# Access Compliance Report

## Public Rights-of-Way

Intersection ID: 51371	Main Street: UNIVERSITY_POINTE_BV	Cross Street: N_TRYON_ST	Location: SW
ADA ID: 48BA4256E989	Ramp Type: Perp	Initial Pass/Fail: Fail	Overall Compliance: No
Severity Score: 10			
Codes/Mitigation Info/Possible Solution		Field Measurements/Component Compliance

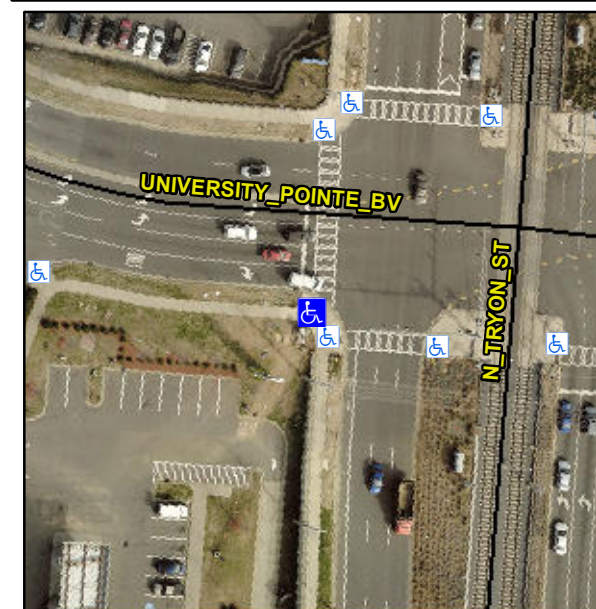
**R304.5.1**

Compliance	Description	Data	Compliance	Description	Data
N/A	Ramp Length (in)	90.0	Yes	Ramp Slope (%)	6.1
No	Ramp Width (in)	47.0	Yes	Ramp XSlope (%)	4.5
N/A	Flare Type LT	N/A	N/A	Flare Type RT	N/A
N/A	Flare Slope LT (%)	N/A	N/A	Flare Slope RT (%)	N/A
N/A	Flare Traversable LT?	N/A	N/A	Flare Traversable RT?	N/A
N/A	Landing Length (in)	N/A	N/A	DWS Provided?	N/A
N/A	Landing Width (in)	N/A	N/A	DWS Contrast?	N/A
N/A	Landing Slope (%)	N/A	N/A	DWS Length (in)	N/A
N/A	Landing X Slope (%)	N/A	N/A	DWS Full Width?	N/A
N/A	Landing Curb? (Y/N)	N/A	N/A	DWS Offset (in)	N/A
N/A	Shared Landing?	N/A			
N/A	Gutter Ponding?	N/A	N/A	Gutter Slope (%)	N/A
N/A	Gutter Lip Ht (in)	N/A	N/A	Gutter X Slope (%)	N/A
N/A	Painted X Walk1?	Yes	N/A	Painted X Walk2?	N/A
	X Walk 1 Direction	To N		X Walk 2 Direction	N/A
N/A	X Walk 1 Width (in)	110.0	N/A	X Walk 2 Width (in)	N/A
	X Walk 1 Slope (%)	1.5		X Walk 2 Slope (%)	N/A
	X Walk 1 X Slope (%)	5.5		X Walk 2 X Slope (%)	N/A

**Remove & Replace Entire Ramp.**

**\$ 1850.00**
